CITY OF ALBUQUERQUE

July 20, 2015

**Re: Winrock Redevelopment Section 2 and Section 4 Grading and Drainage Plan
Engineer's Stamp Date 7-20-15
Drainage file number (J19D058C)**

PROJECT TITLE	WINROCK SECTION 2 AND 4
PROJECT MANAGER	WINROCK TOWN CENTER ALBUQUERQUE, NEW MEXICO
JOB NO.	303689.01
DRAWN BY:	KLS
SHEET TITLE	HYDROLOGICS - INLET CAPACITY

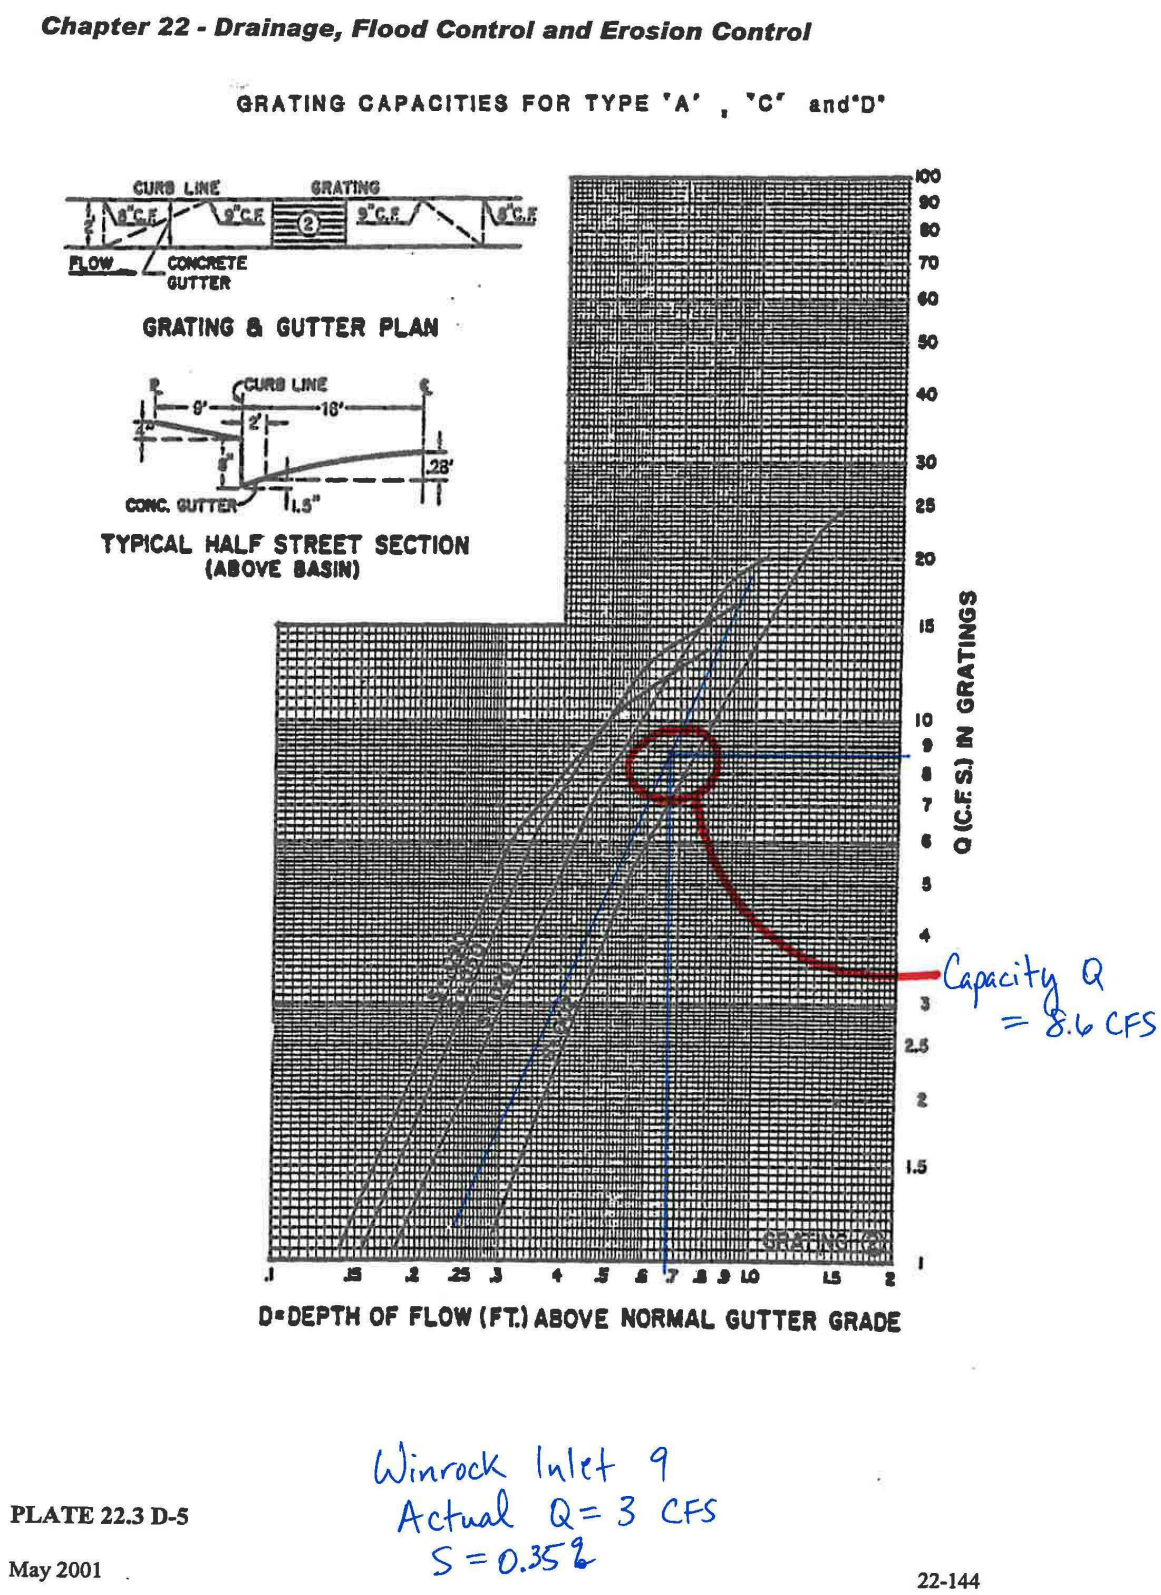
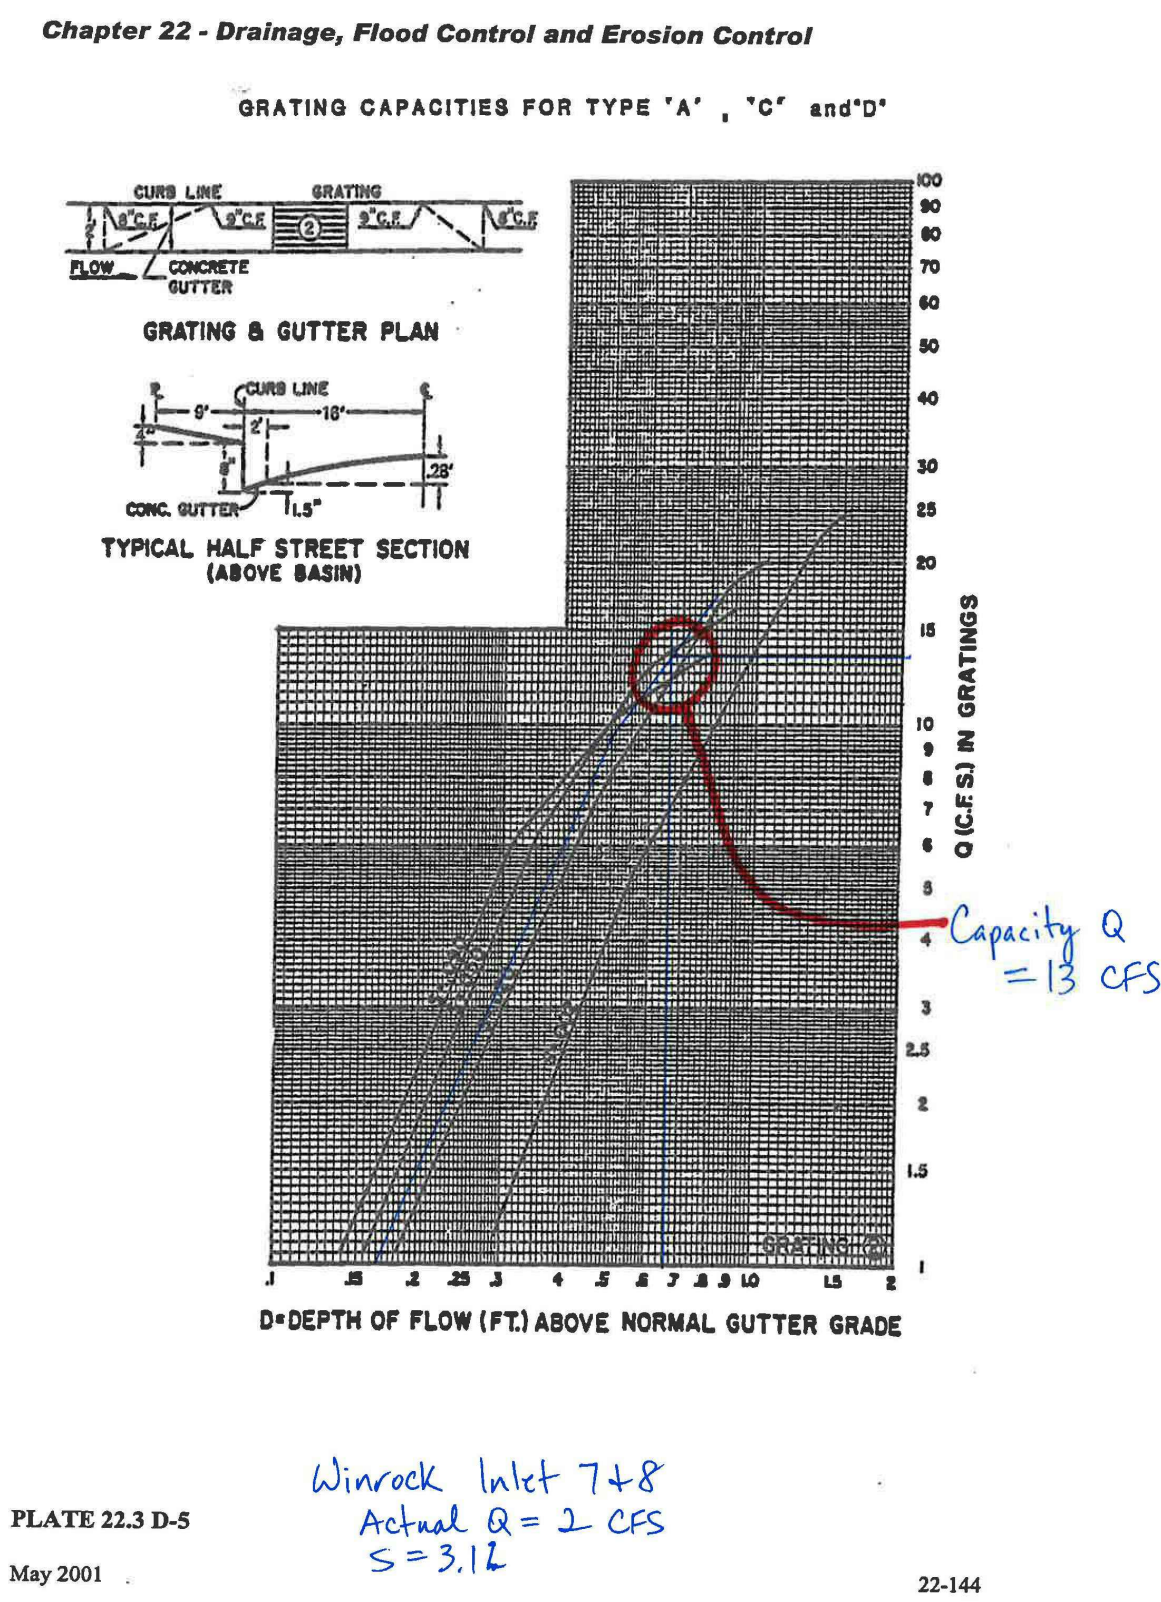
3. Inlet 6 is proposed as a Triple "C" inlet. However, the City does not have a standard drawing for a Triple "C" inlet so a Double "C" inlet with a connector pipe to an "A" inlet may work. This can be addressed on the Work Order plans.

C505

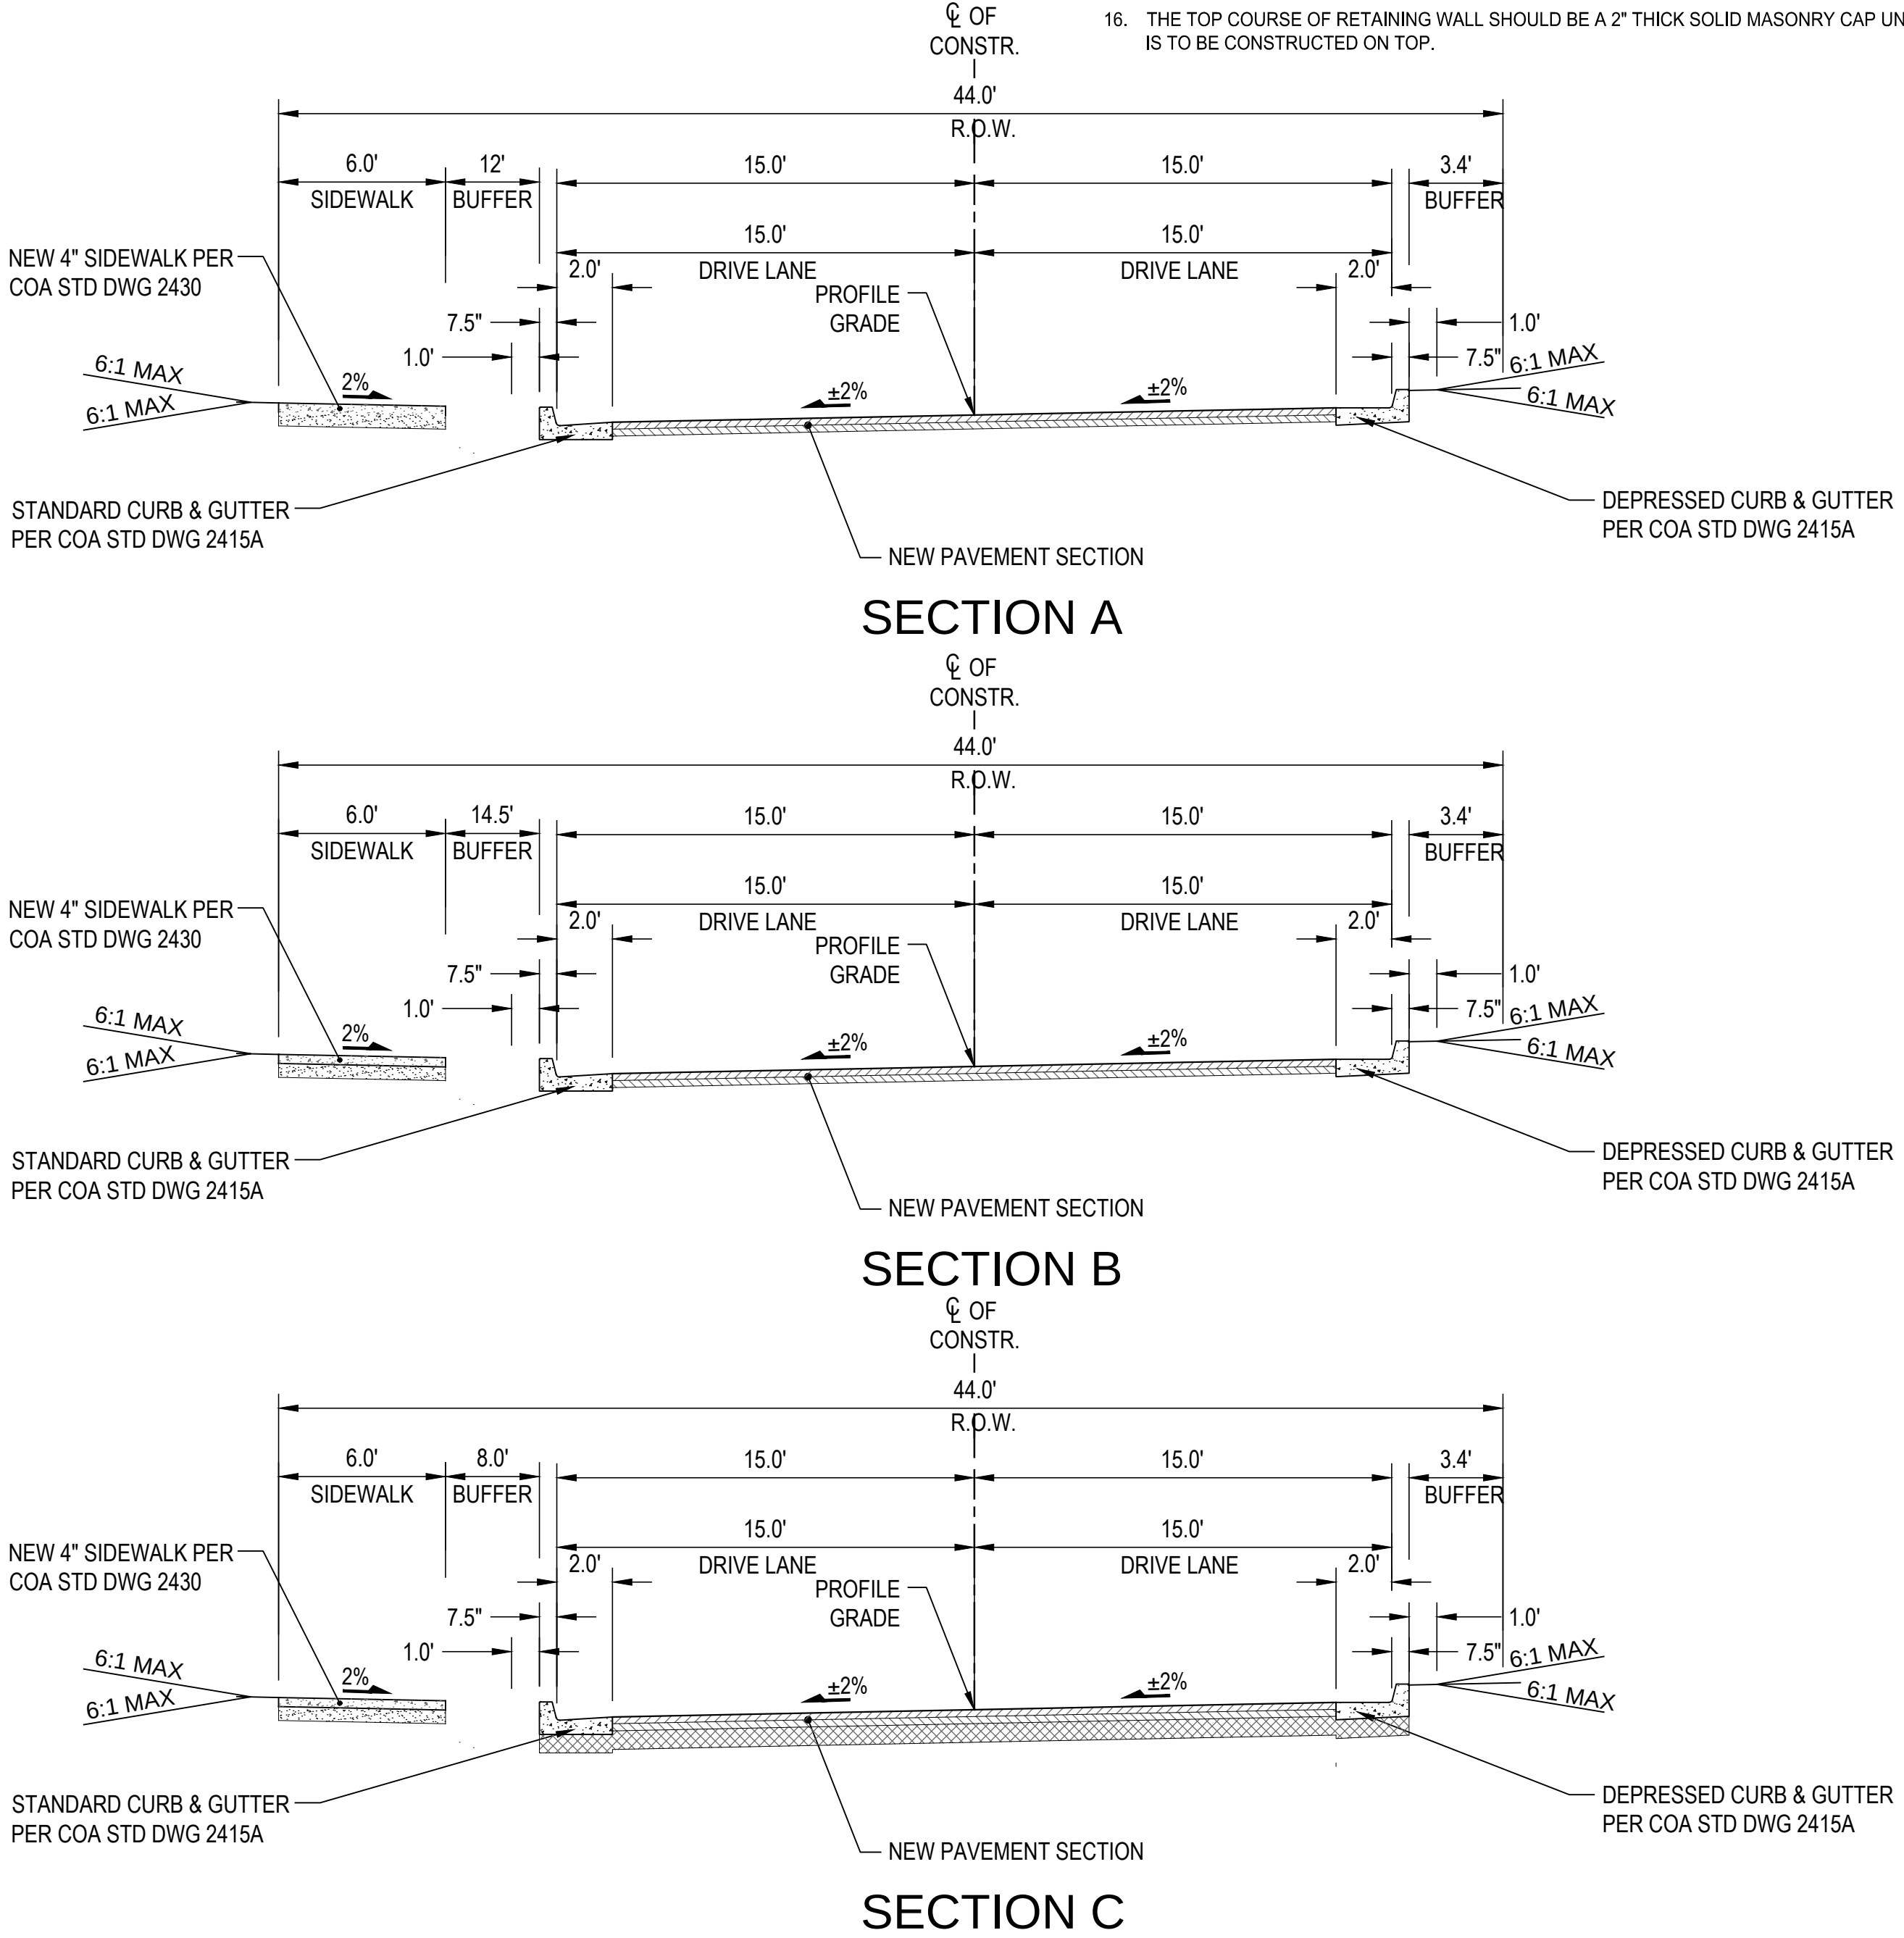
10. The first flush depressed area was inadvertently omitted in Sections A, B, and C on Sheet C505.
